RE: Data Response, Set 2K
Ivanpah Solar Electric Generating System (07-AFC-5)

**Attachment DR125-3B
Closure, Revegetation, and Rehabilitation
Plan for the Ivanpah Solar Electric
Generating System
Eastern Mojave Desert
San Bernardino County, California**

In addition, Attachment DR125-4A is a response to the comments received on the January 28, 2009 version of the CR&R Plan.

Figure 1-3
Features to Remain After
Plant Decommissioning

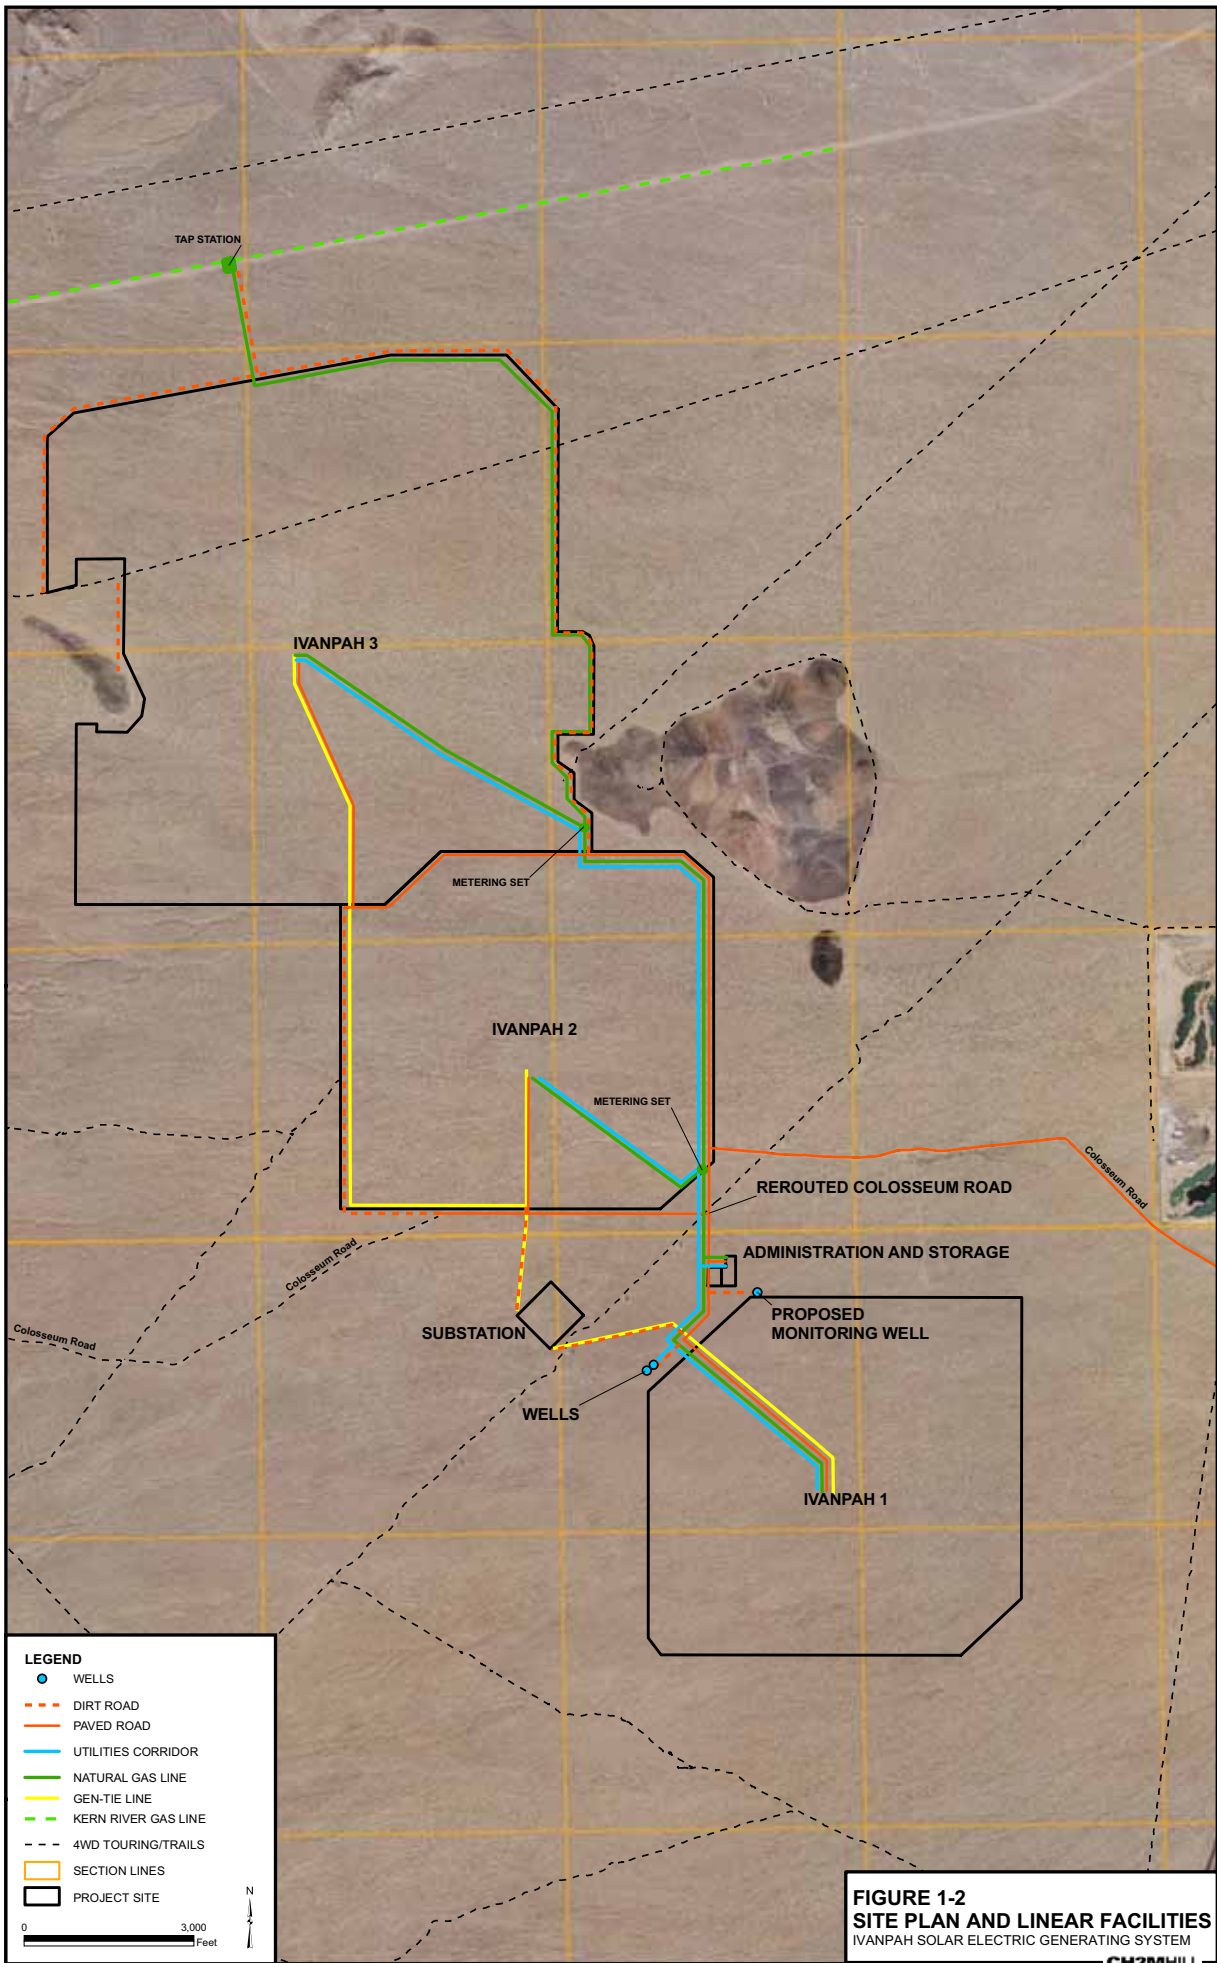
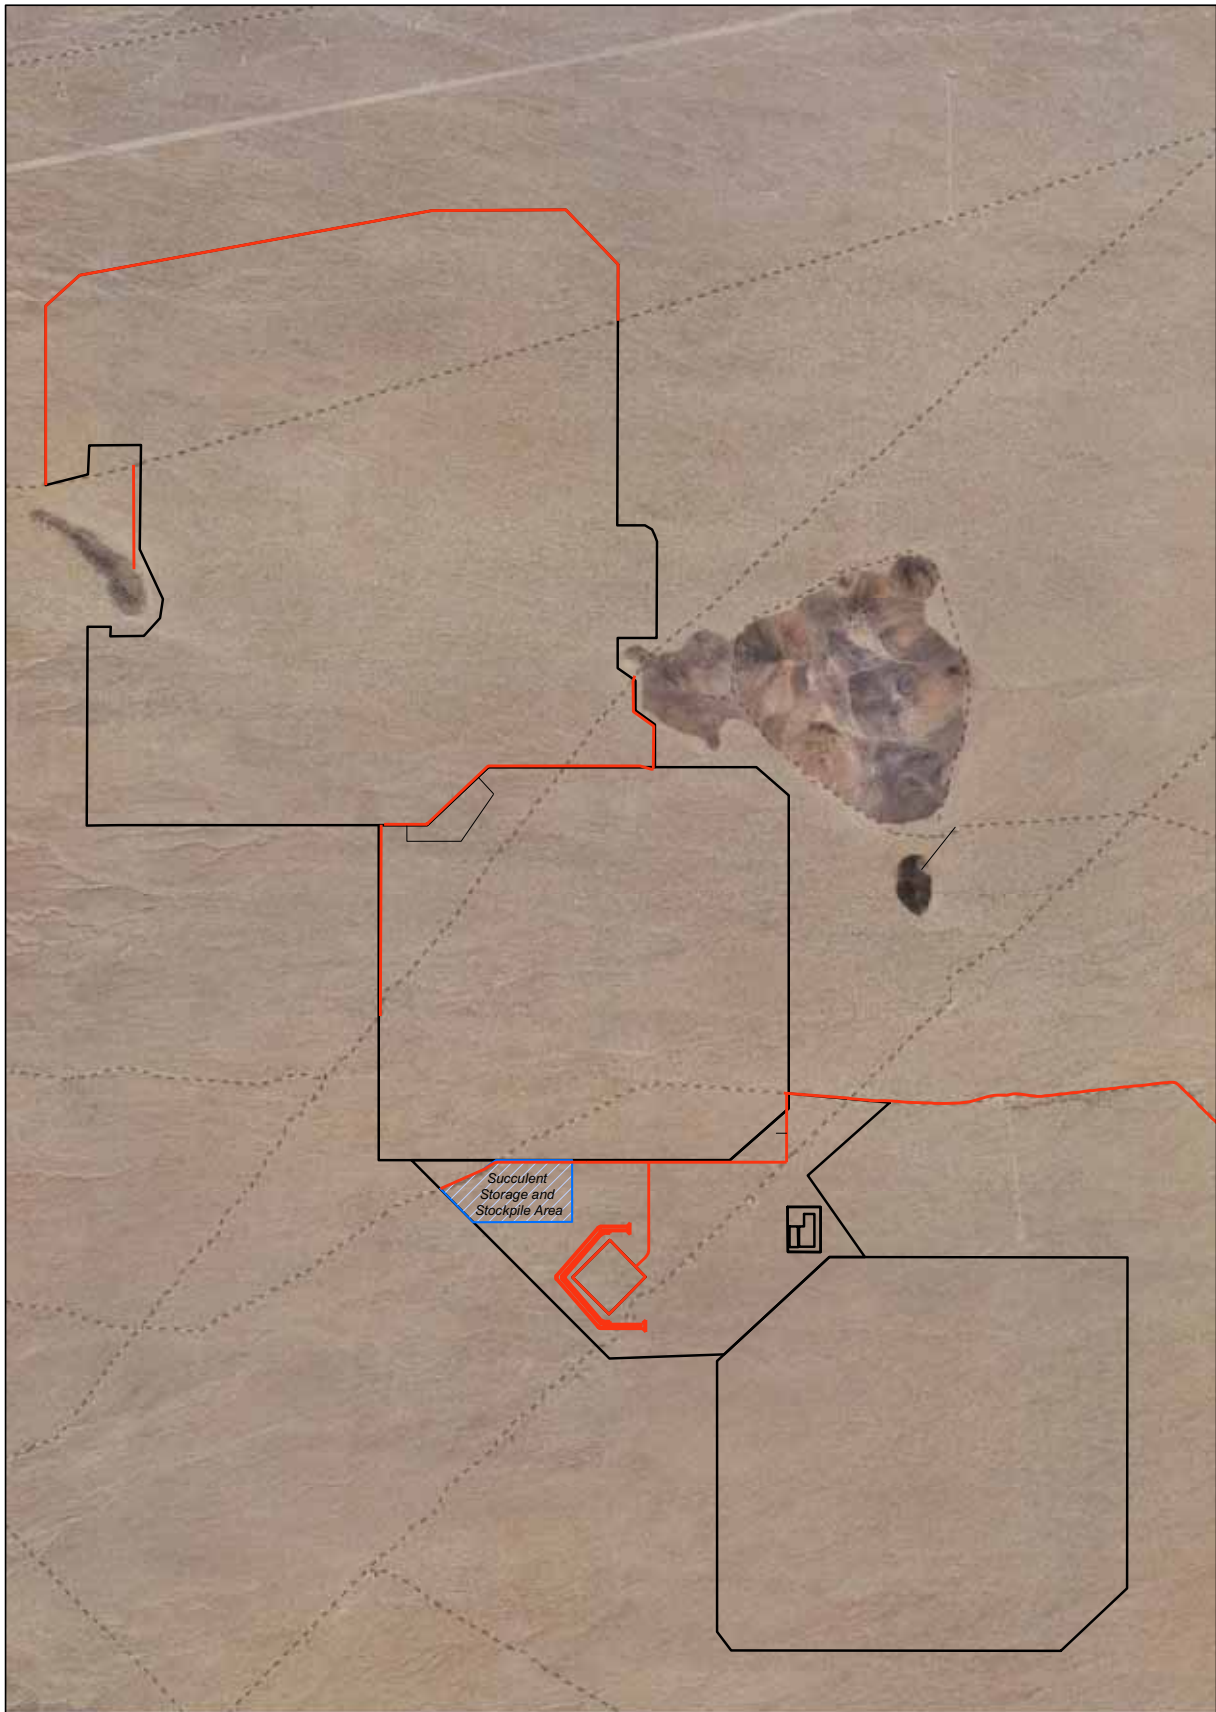
The Applicant agrees that succulents should be used for long-term revegetation. As described in Section 1 and shown in Figure 1-3, the Succulent Storage and Stockpiling Area (SSSA) is a 40-acre area to be located in the Construction Logistics Area (CLA). It will be used first for temporary treatment and storage of salvaged succulents, and eventually for their long-term stockpiling through plantation (in the general fashion of a mesquite (agave) plantation in the semi-arid parts of Mexico). The SSSA will be maintained for the planned life of the facility, and succulents from its plantation will be used in revegetation after

The R&R Plan has been revised to commit to the salvage, long-term storage, and eventual transplanting of succulents following decommissioning. Sections 4, 7, and 8 now describe these measures in some detail. A 40-acre succulent storage (for short-term) and stockpile (long-term plantation) will be located inside the Construction Logistics Area between Ivanpah 1 and 2. Section 4 also provides transplanting and replanting guidelines based on size and morphology, and the size criteria for succulents to be transplanted, versus those to be left in place under LID technology, have been specified in Section 4.5.1.
